This is to certify that Harbor Plaza Associates Ii/Bo Signs  
has permission to Replace 1 wall sign (on Union St.) & a wall projecting sign on Fore St. (both internally illuminated)  
AT 456 Fore St 038 E009001

**City of Portland, Maine - Building or Use Permit Application**

456 Fore St. - Portland Harbor Hotel  
permit # 06-0531

ITEM C D/F ILLUMINATED PROJECTING SIGN  
SCALE: 1/2" = 1'-0"

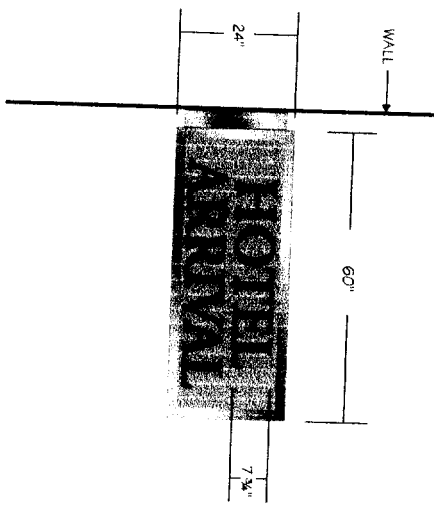
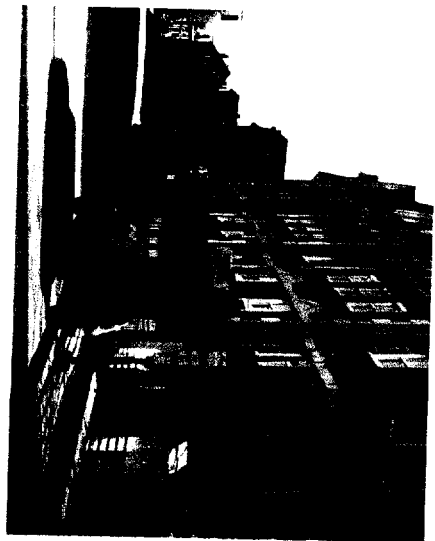
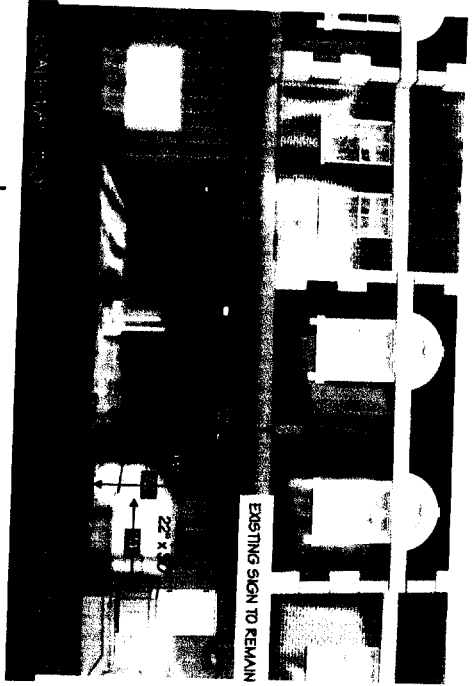
**Comments:**  
4/28/2006-amachado: Need certificate of insurance & dimensions of existing sign on Fore street. Talked to Jen at Barlo signs.  
6/27/2006-mjn: left message w/Barlo sign, the overhanging sign appears to exceed the limitations of Sectionb 3202.3.1 of the building code. Will also want some engineering.

**ITEM A S/F ILLUMINATED SIGN**  
 SCALE: 1 1/2" = 1'-0"

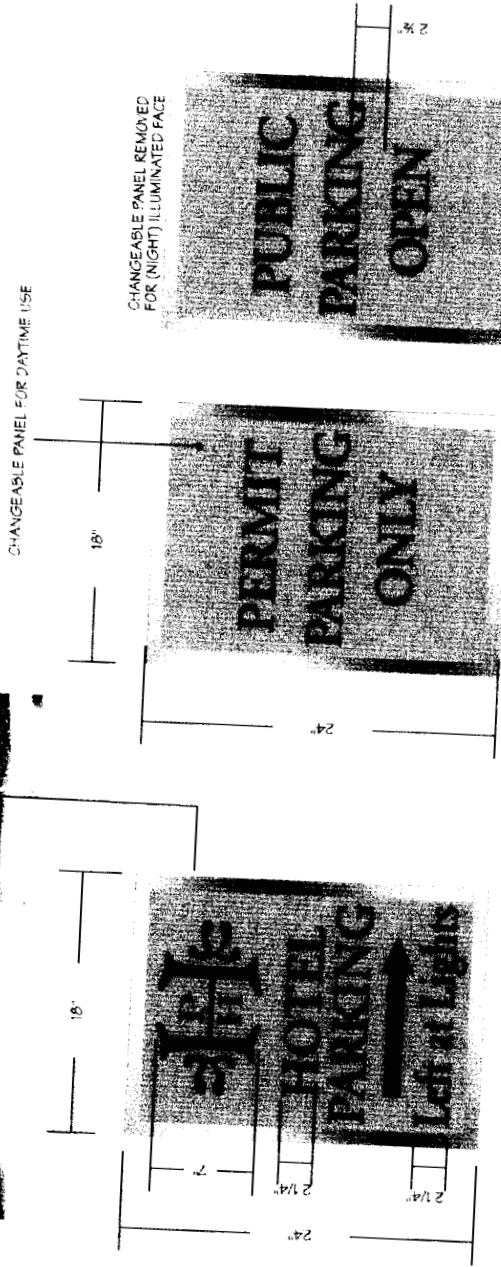
new signs in  
 Union St.
